Your ref: SSD-50629707  
Our ref: DOC24/344391

**Subject: The Plains Wind Farm EIS (SSD-50629707)**

ATTACHMENT A – BCS Assessment Summary for The Plains Wind Farm Environmental Impact Statement (SSD-50629707)

ATTACHMENT B – Detailed advice for The Plains Wind Farm Environmental Impact Statement (SSD-50629707)

**Figure 4: Proposed tracks and cable routes through intact native vegetation (PCTs 13 and 153), noting that the turbine location spatial data and development footprint are not consistent in this location.**

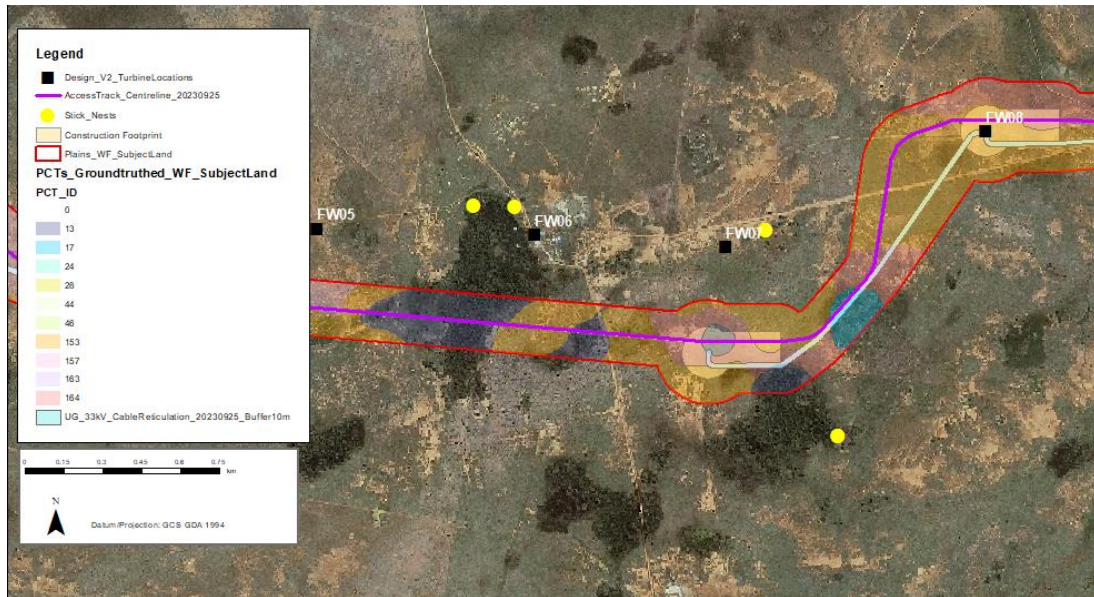
The proposed new track and cable reticulation trenching between some turbine locations does not appear to have been located to maximise the existing track network and avoid native vegetation. For example, around turbine location FW06 shown on Figure 4, a cable reticulation route is proposed to go through intact native vegetation (including PCT 13 Black Box – Lignum woodland wetland) instead of being co-located with the nearby existing track network. We note that the spatial data for proposed turbines does not match the disturbance footprint in this location.

- 13.1. Provide detail for all avoid and minimise measures to be implemented through post-approval environmental management plans, in accordance with BAM sections 7.1.2 and 7.2.2(2).
- 13.2. Demonstrate avoidance by revising the proposed location of all tracks and cabling to ensure the existing network is used, and that cable reticulation is co-located with tracks or within existing cleared areas wherever possible.

**Figure 5: New tracks and cable routes proposed around Turbine EW06 through native vegetation instead of following existing tracks.**

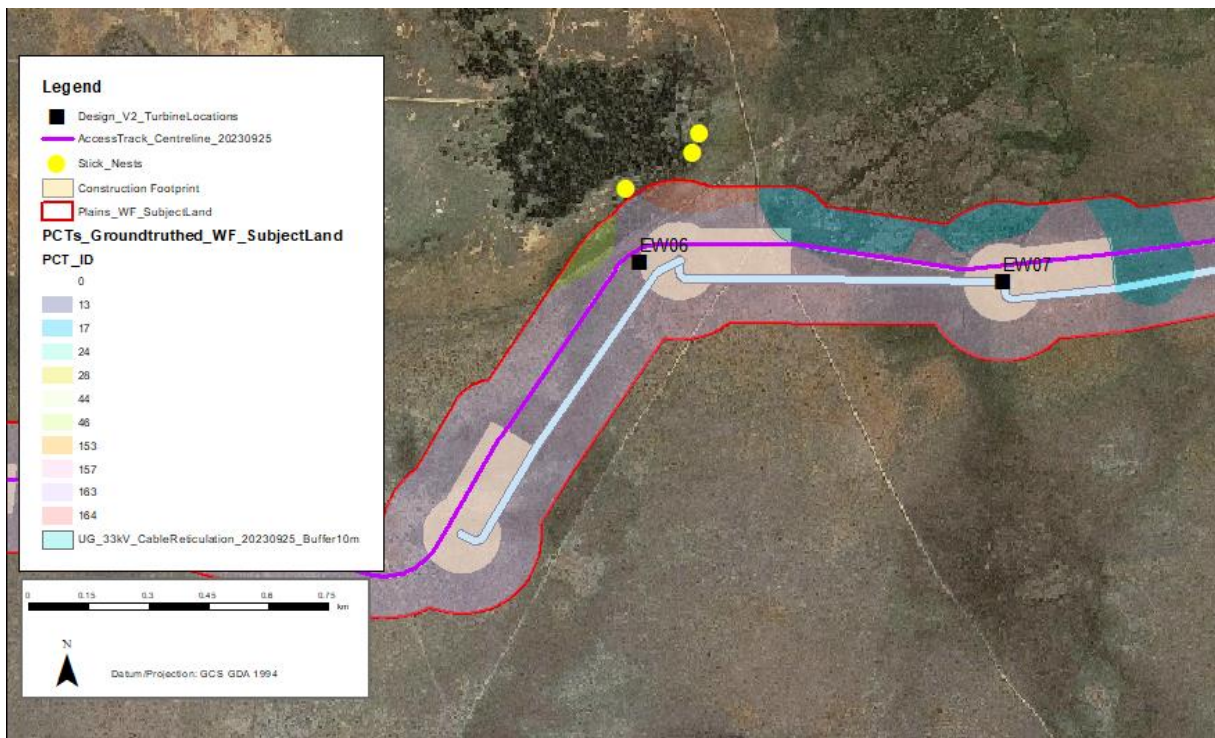
Similarly, the existing track network has not been used for tracks or cabling either side of proposed turbine EW06 shown on Figure 5. The proposed location of all tracks should be re-visited to ensure the existing network is used, and co-locating cable reticulation with the existing disturbance.

The network of access tracks will impact 5.35 hectares of Important Habitat Map for the SAll Plains-wanderer. Despite section 7.1.1 of the BDAR saying that existing access tracks have been used where possible, this statement is not reflective of the maps and spatial data which shows new access tracks next to existing access tracks (see Figure 5).

**Figure 6: Known location of SAIL *Calotis moorei* in development footprint despite BDAR saying impacts will be avoided.**

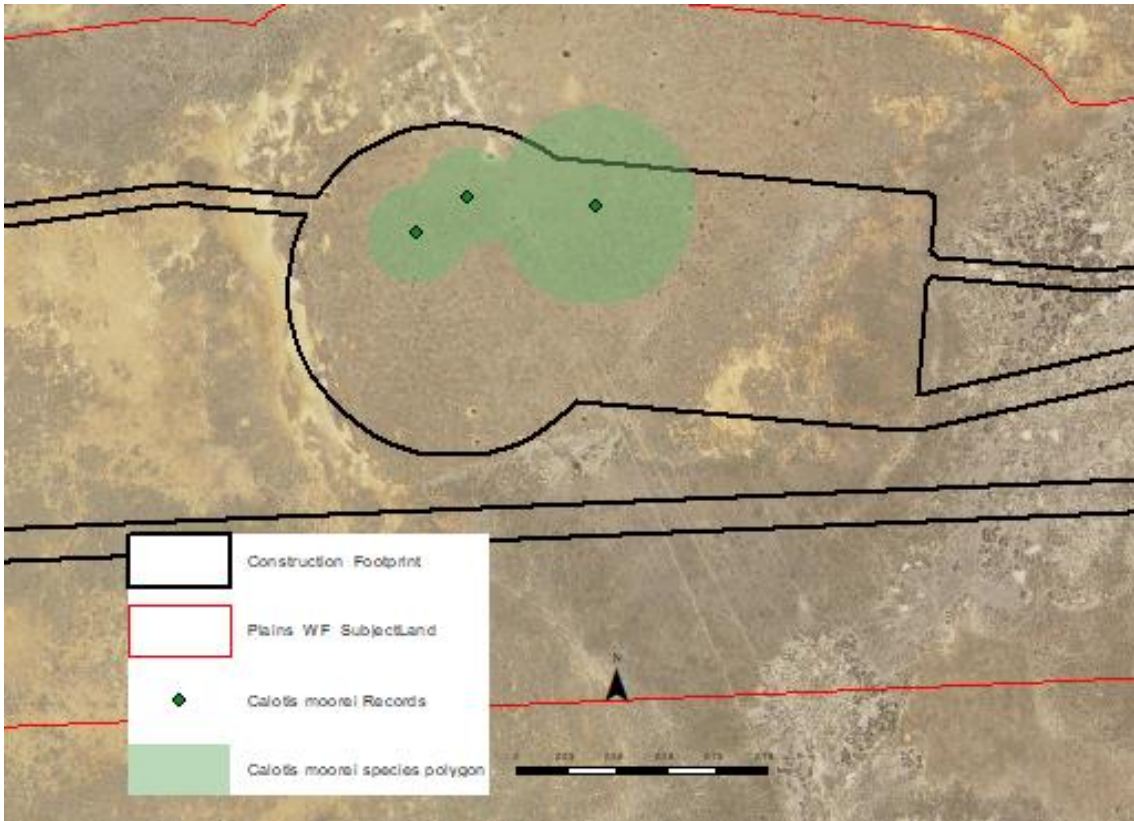
*“the Project will aim for the total avoidance of Calotis moorei...”*

This statement does not match the reported impacts in the BDAR or BAM-C for this species where the development footprint includes complete removal of the identified population of *Calotis moorei*. There are also areas of assumed presence within the development footprint. The vague commitment of aiming to totally avoid impacts to the species is not supported by the species polygon at a turbine location (Figure 6) and the required credit obligation.
